UNITED STATES OF AMERICA
NUCLEAR REGULATORY COMMISSION

In the Matter of)	
)	
LONG ISLAND LIGHTING COMPANY)	Docket No. 50-322-OL-3
)	(Emergency Planning
(Shoreham Nuclear Power Station,)	Proceeding)
Unit 1))

LILCO'S TESTIMONY ON CONTENTION 49
(NOMOGRAM FOR THYROID DOSE)

TCS AIR SAMPLER OFFSITE THYROID DOSE NOMOGRAM - SHOREHAM STATION

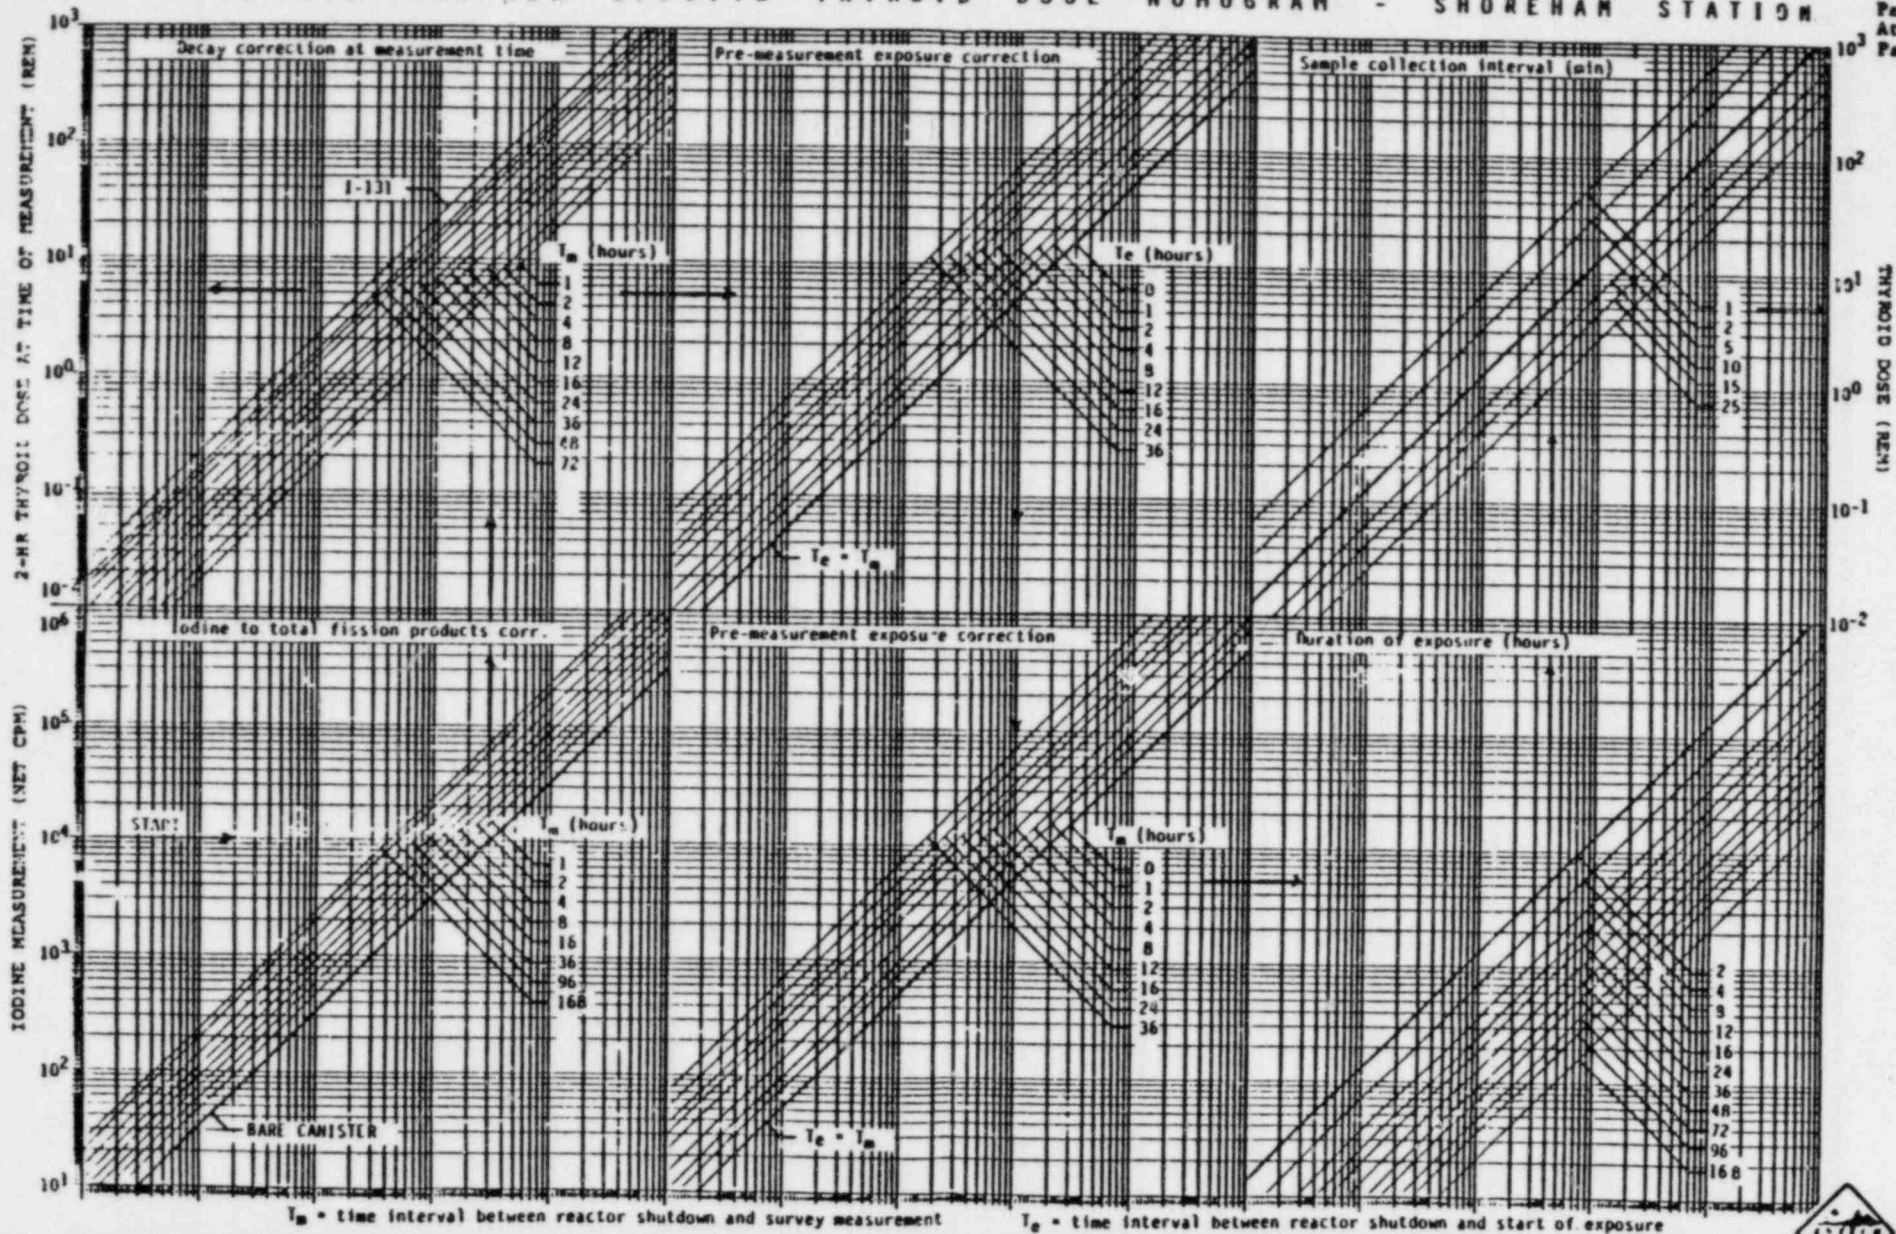
The nomogram which relates iodine to total fission products for the calculation of thyroid dose (OPIP 3.5.2 Attachment 11) is not realistic. Thus, there is no assurance that this procedure will provide reliable data for use in making protective action decisions. Accordingly, there is no compliance with 10 CFR Section 50.47(b)(9).

[T]he nomogram which relates iodine to total fission products for the calculation of thyroid dose (OPIP 3.5.2 Attachment 11) may not be realistic in this aspect [that "even without core damage, radioiodine may be collected on the particulate filter if the iodine is in elemental form. Therefore, one cannot rule out activity on the particulate filter as not being iodine.] Furthermore, the amount of fission products collected from a core damage accident are [sic] highly dependent on a number of parameters, such as moisture in containment, filtration of release, distance from the site, etc., and are [sic] not easily amenable to the nomogram assumptions.

A. The FEMA review noted two areas in which FEMA thought the nomogram was unrealistic. First, FEMA commented that without core damage, radioiodines may be

collected on the particulate filter if the iodine is in elemental form. Therefore, it is conceivable that the activity measured on a particulate filter may be iodine. The second question in the FEMA comment notes that the amount of fission products collected from the core damage accidents is highly dependent on a number of parameters such as moisture, containment filtration of release, and other removal mechanisms that are not easily amenable to the nomogram assumptions. It is for these reasons that the FEMA review questions whether the nomogram is realistic.

The contention reflects two questions raised in the FEMA-RAC review. The first is that the nomogram is not always used to calculate the thyroid dose from radioactivity measured on the particulate filter paper. In response to this, the

procedure has been modified so that the thyroid dose from the radioactivity on the particulate filter paper is always calculated. The second question is whether the thyroid dose determination might not be accurate due to filtration, moisture in the containment, and other removal processes. As shown in the testimony, these effects only reduce the amount of radioactive material released, and the air samples taken in the field can be remeasured in laboratories where no assumptions concerning the release need be made.

11. Q. As to the first concern, does the nomogram account for particulate iodine that may be collected on the particulate filter paper?
- A. Yes, the nomogram does account for particulate iodine collected on the filter paper. A radioactive plume released during an emergency could consist of gaseous and particulate material. Both of these types of emissions could include radioactive iodine, which, when inhaled, would result in a dose to the thyroid. The TCS Air Sampler System used in the LILCO Plan consists of an air pump and a sampler canister which is filled with absorbent material and surrounded by a particulate filter. The outside filter is a very fine paper which is designed to trap particulate

However, the outer filter paper may contain both iodine and non-iodine particulate material. The nomogram procedure assumes a certain mixture of iodine and non-iodine particulate material to be present on the filter paper; the radioactivity of this mixture is further assumed to vary as a function of time. Thus, the nomogram allows one to calculate how much of the measured radioactivity on the filter paper is due to particulate iodine at various points in time.

The nomogram procedure then allows the total thyroid dose from gaseous and particulate iodine to be calculated. This is accomplished by determining the gaseous and particulate components of the thyroid dose separately, and then adding them.

A. The LERO procedure OPIP 3.5.2 states in notes on pages 18 of 56 and 54 of 56 (Attachment 4 to this testimony) that unless there is core melt or fuel damage it is not expected that there will be any iodine released in particulate form and therefore no iodine radioactivity will be found on the filter paper. Thus, it is not necessary to calculate a thyroid dose from the filter paper measurement but only from the inner canister. Pursuant to FEMA's comment that even without core melt or fuel damage, radioiodine may be released and collected on the particulate filter paper, the procedure will be modified in future revisions to the LILCO Plan to remove the notes on pages 18 and 54. Thus, the radioactivity measured on the filter paper will always be included in the thyroid dose calculation.

A. Yes. The determination of the radioiodine fraction of the fission product release was based upon an analysis of different release scenarios for BWR accidents. The procedure uses a most probable iodine/total fission product ratio for the accident scenarios analyzed.

A. Yes. As discussed above in this testimony, the particulate component of any accidental release will be accounted for by the TCS sampler method by always checking for the presence of radioactivity on the outer filter paper following sample collection.

Because radioactive material detected on the filter paper is likely to include a mixture of iodine and non-iodine particulates that varies with time, the nomogram includes a correction step to account for this variation. The nomogram correction reflects the most probable ratio of particulate iodine to total
